RE: DC SHPO Comments on the Assessment of Effects Report for the Triumphal Arch Project

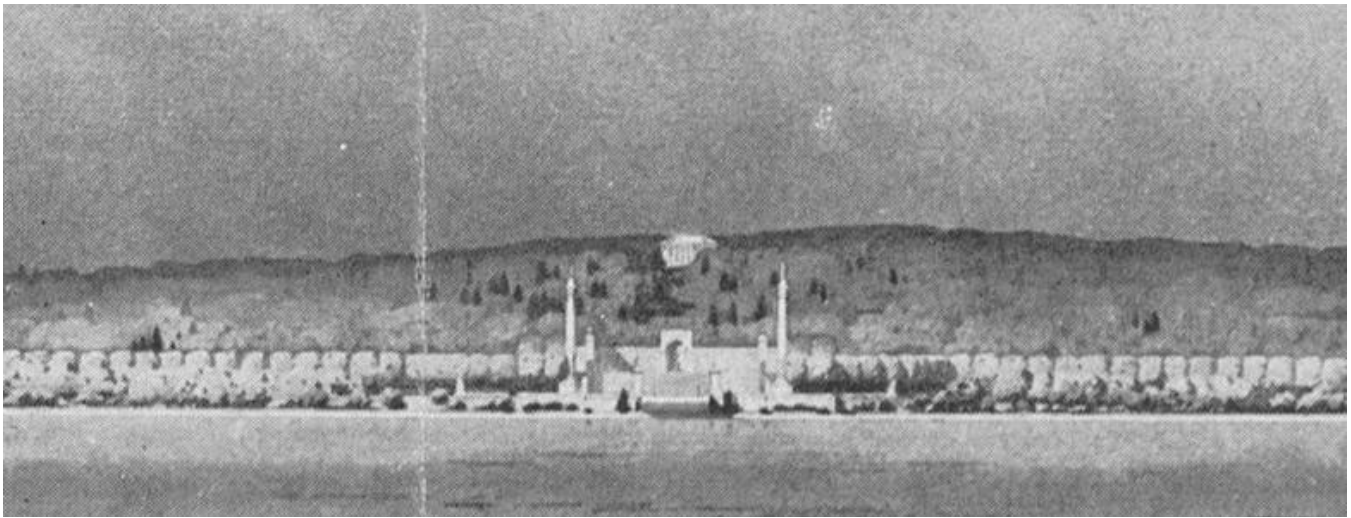
Obviously, neither the 1925 Act of Congress nor the design of Memorial Circle contemplated the 250th anniversary of our nation since both were completed over a century before the event. Moreover, McKim Mead & White’s design envisioned two slender columns carefully situated to frame the view between the Lincoln Memorial and Arlington House and to more directly signify reunification by using one column to symbolize the North and the other, the South (see rendering below).

In stark contrast, the proposed Triumphal Arch would effectively replace much of the important view with a frame – a massive frame that would significantly narrow and restrict, if not completely obstruct portions of the view corridor. And since the proposed arch does not symbolize reunification in any way, it would be more accurate to describe the current proposal as antithetical to McKim Mead & White’s design and the 1925 Act than to suggest it will fulfill or complete them in any way.

Since NPS seems convinced that Memorial Circle is the most fitting site for a commemorative monument, we request meaningful consideration of an alternative that more accurately reflects the spirit and intent of the 1924 McKim Mead & White design and the 1925 Act of Congress. Specifically, we request the NPS to evaluate design concepts consisting of two columns that truly frame, rather than limit the historic view corridor. We maintain that the development and meaningful consideration of some such alternative designs and/or alternative locations is essential for the NPS to comply with the most fundamental requirements of Section 106 for this undertaking.
